RE: NextNet Wireless, Inc.

FCC ID: PHX-PCC2510 (*questions are in regard to FCC application for PHX-PCE25100*)

Motorola reply to "ATCB Comments 022808" for PHX-PCE25100

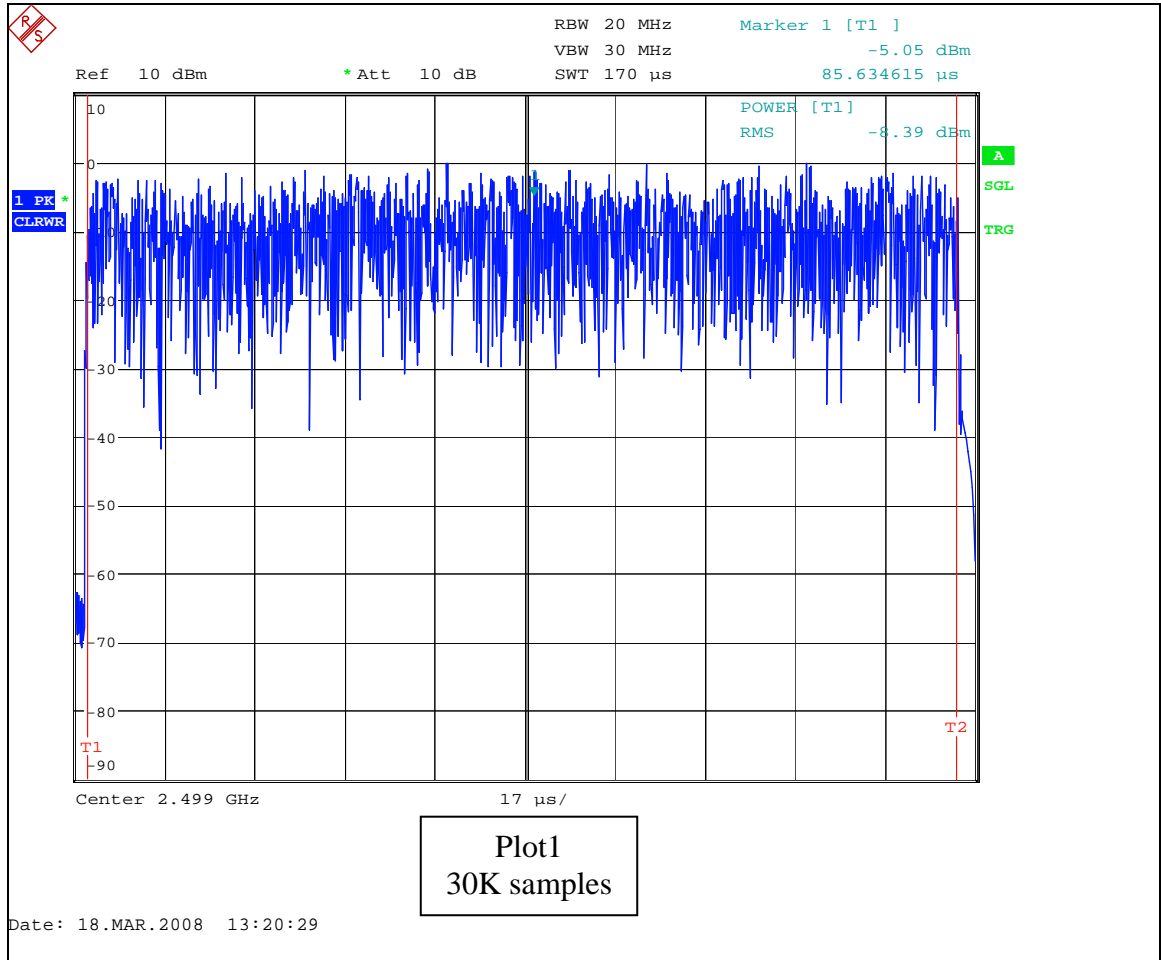
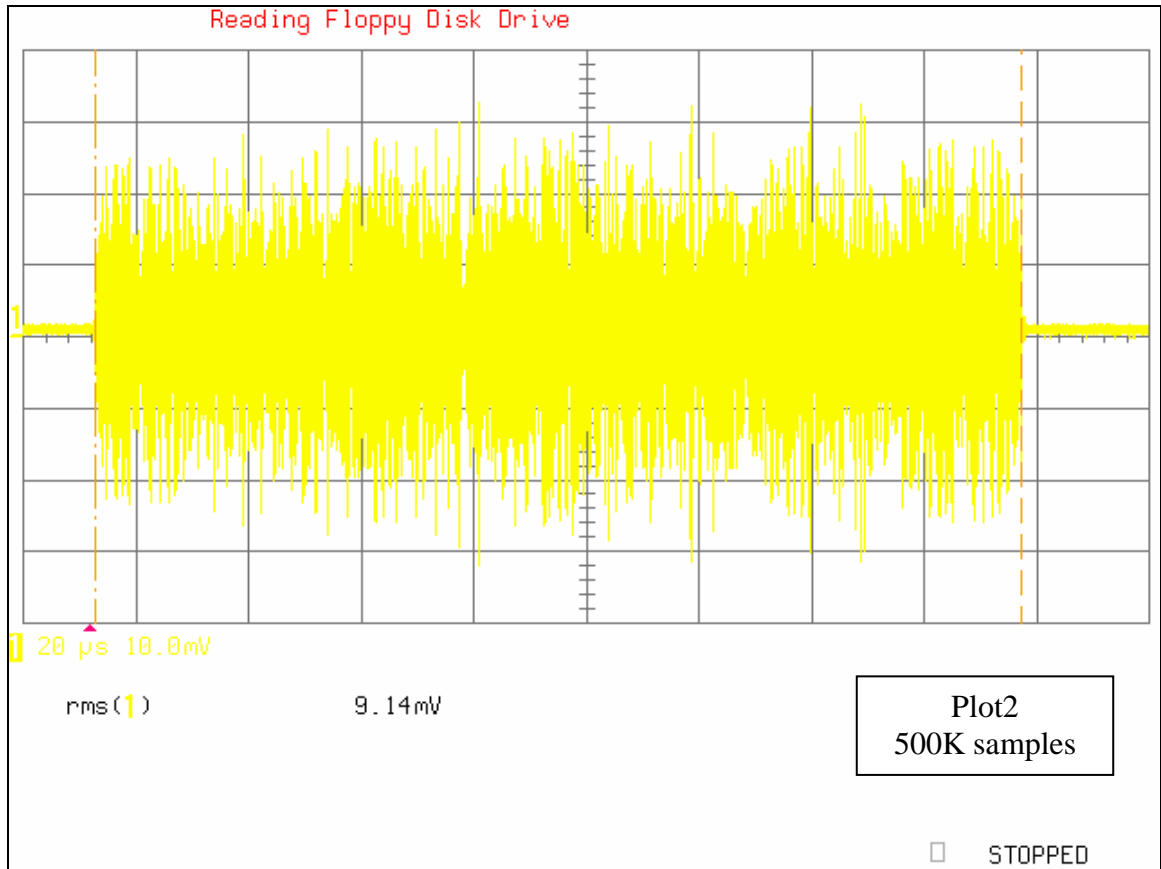
2) The power measurement appears to use a 0 Hz span, peak detector, but then possibly the final power is the RMS value of the bin values obtained. I do not believe this will meet FCC's expected Peak value given past discussion on peak vs. RMS. Please provide appropriate detailed explanation. Note if necessary, we can let FCC determine appropriate nature of test during the Permit but Ask. However given past discussions, it appears unlikely they would accept.

A subscriber device is attached to the FSU spectrum analyzer through the appropriate attenuators and coax to ensure that the FSU is operating within its linear range. The 404.4 MHz IF output of the FSU spectrum analyzer is cabled to the input of a LeCroy LT374 Digital Storage Oscilloscope (500 MHz, 4GS/s). A block diagram of this setup is shown below.

The subscriber device transmitter is enabled and a single transmit burst is recorded by the spectrum analyzer and oscilloscope.

The spectrum analyzer power measurement function reports a value of -8.39 dBm. This specific value is not significant other than it will be used as a reference for comparison.

The RMS voltage measured by the oscilloscope for the RF burst from Plot1 is shown to be 9.14mV. The measurement is made between the red markers shown in the plot.
